AGENDA
Regular City Council Meeting
Monday, May 2, 2022, 6:00 PM
Council Chambers, 116 First Street, Neptune Beach, Florida

Subject: Senior Center Porch Plans Review

NEW PORCH
NEPTUNE BEACH COMMUNITY CENTER
NEPTUNE BEACH, FLORIDA

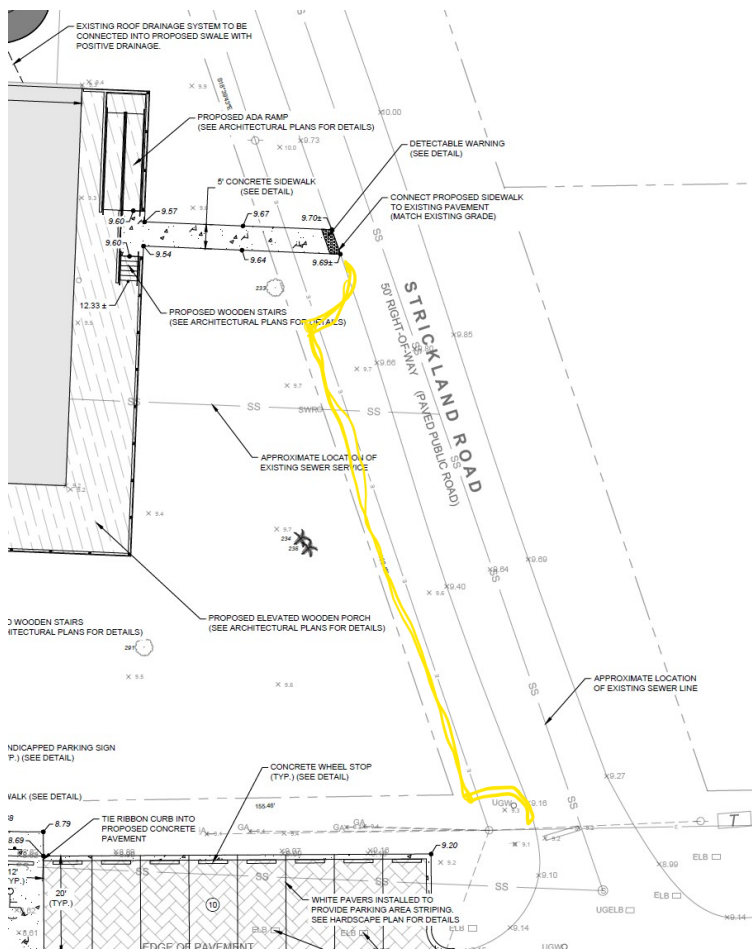
- Front of building and dead space to the right of the window – can we put a dedication plaque?
Per our discussion, I understand that Leslie is working on this item. I'd suggest a 2x3 or 3x4 dimensions.
- East side of building alternate bids for faux shutters and cupola at sidewalk entrance to building.

Les is adding these to the plans. We think that more traditional faux shutters (versus Bahamian) will help to resolve the issue of them sticking out, so I asked Les to add this in. See sketch below.

Right Elevation
1/4" = 1'-0" East

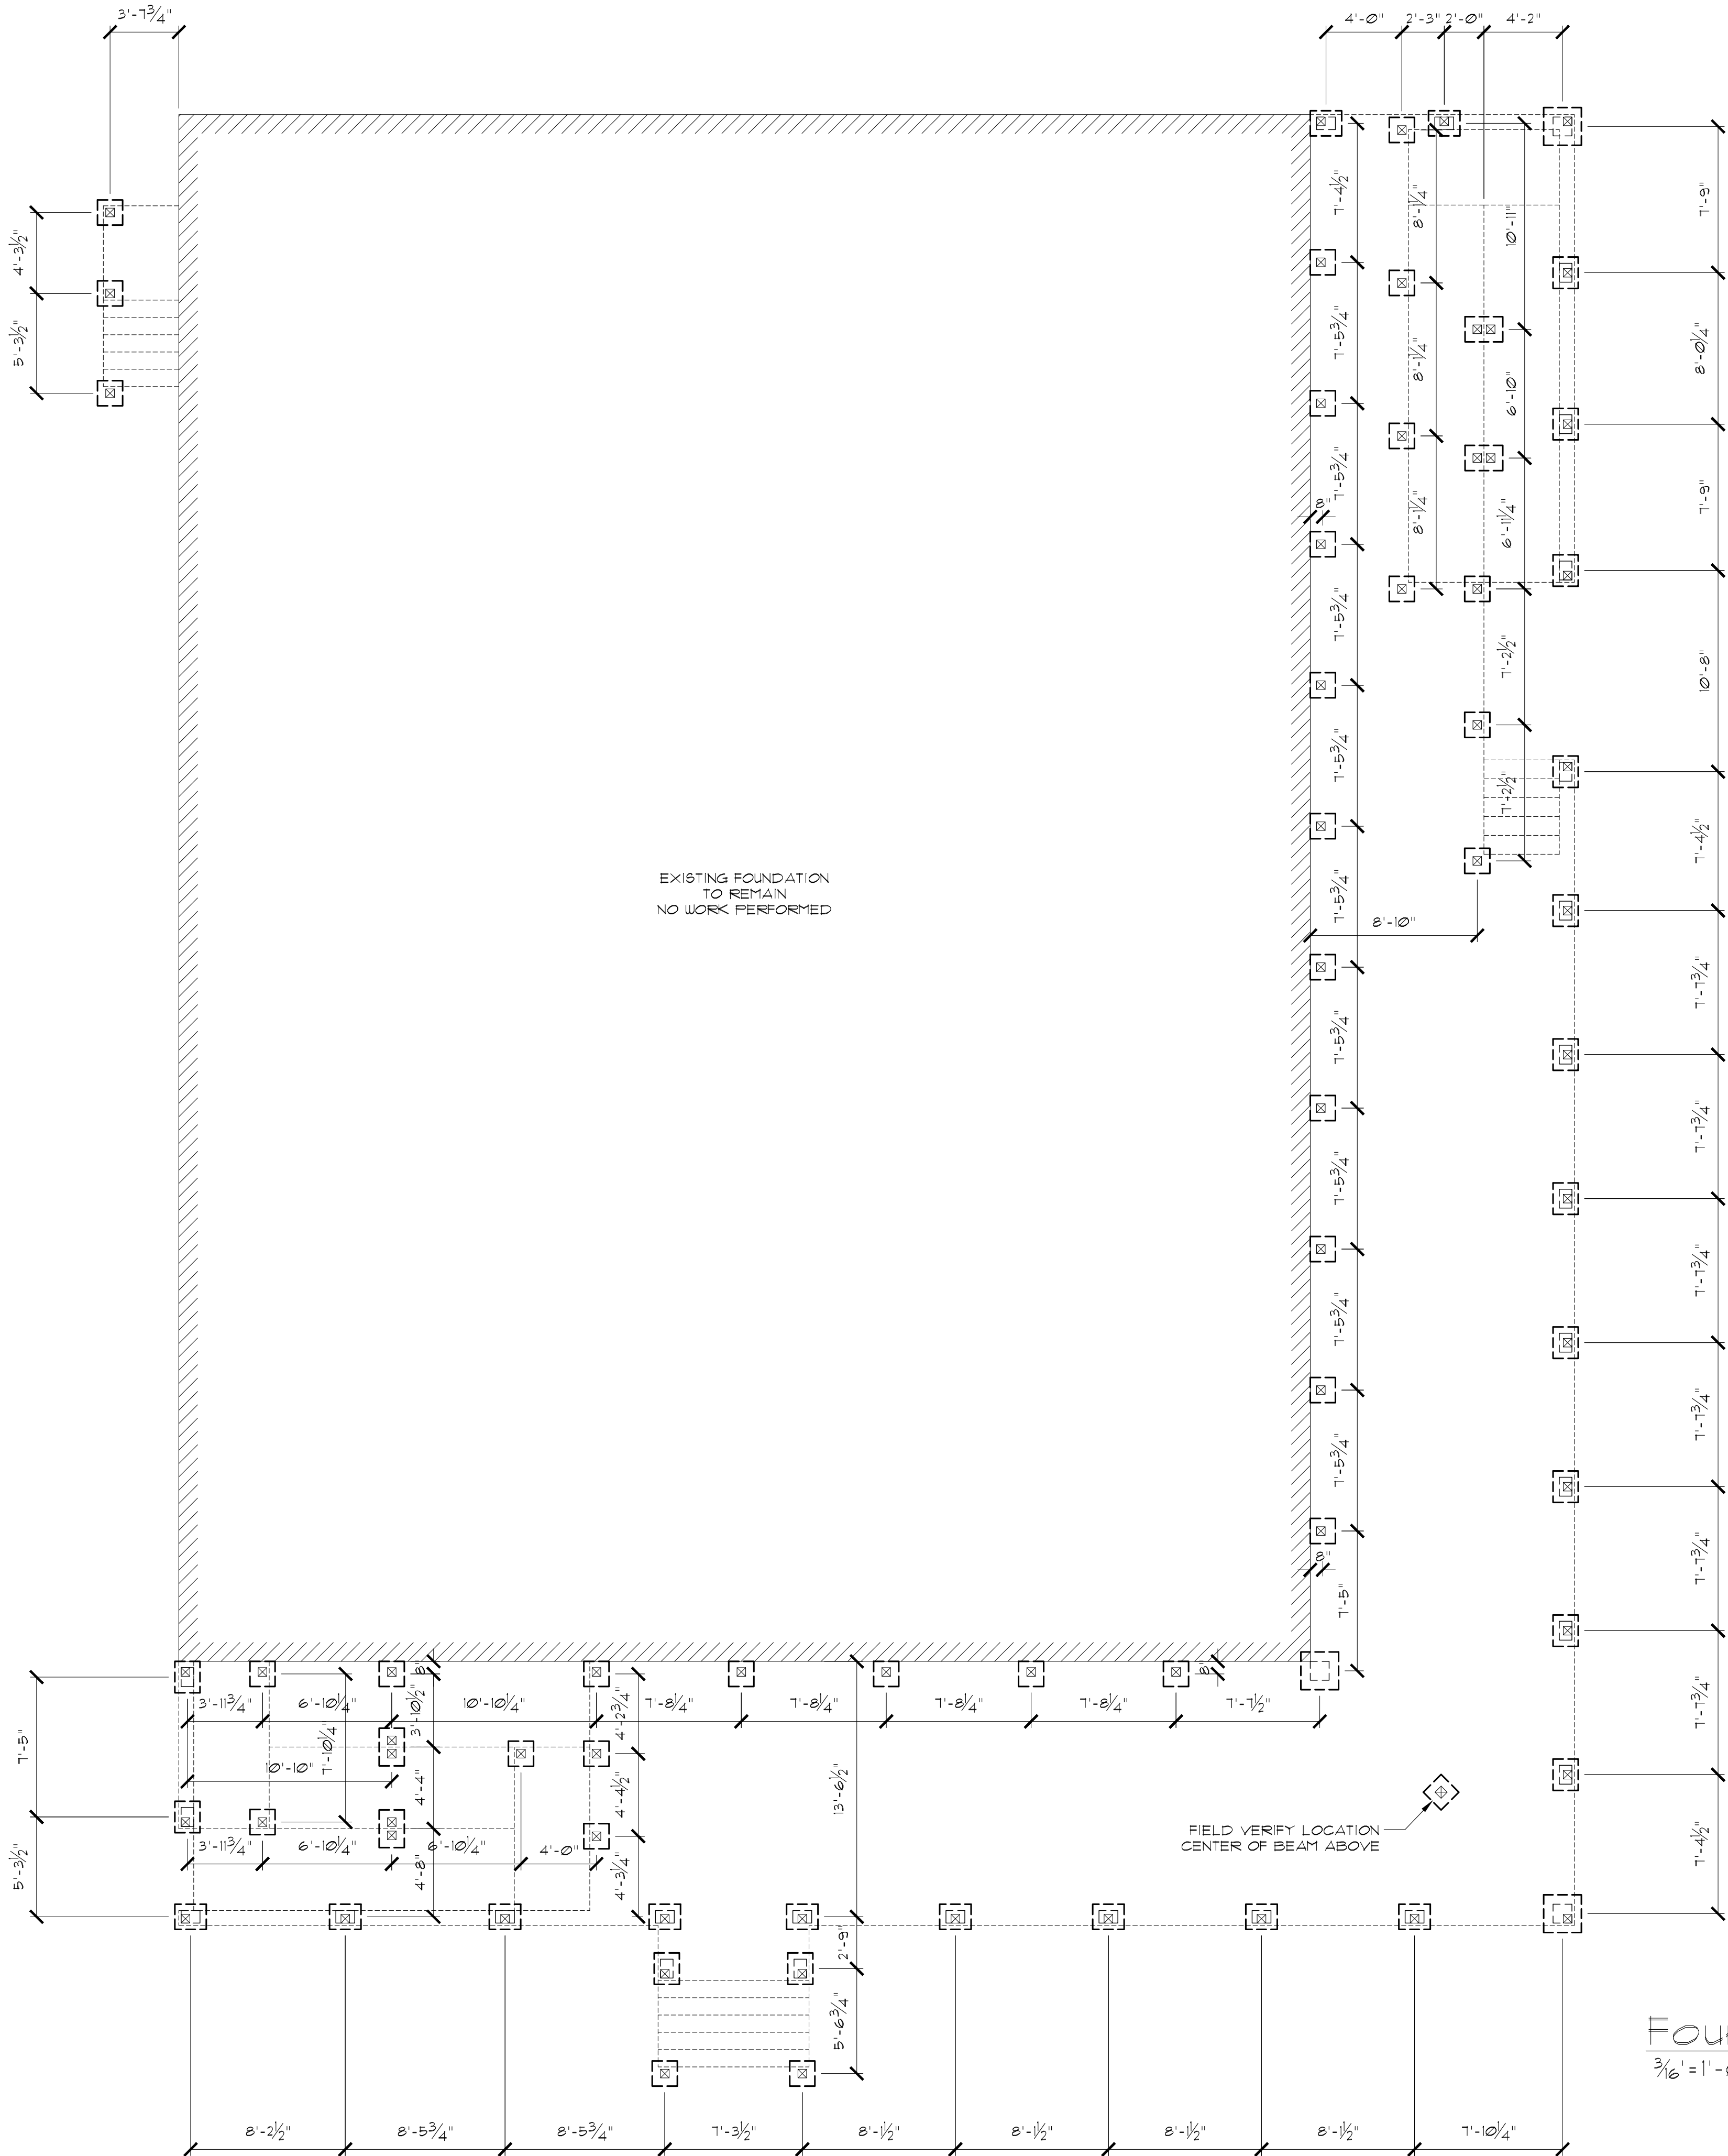
- Sheet A3 displays the elevations. However, no height measurement was provided. Height should be measured to the ridgeline of the structure or the structure's highest point. Additionally, the "Right Elevation" does not include the ADA ramp placement. This elevation should be revised to display the proposed ramp.
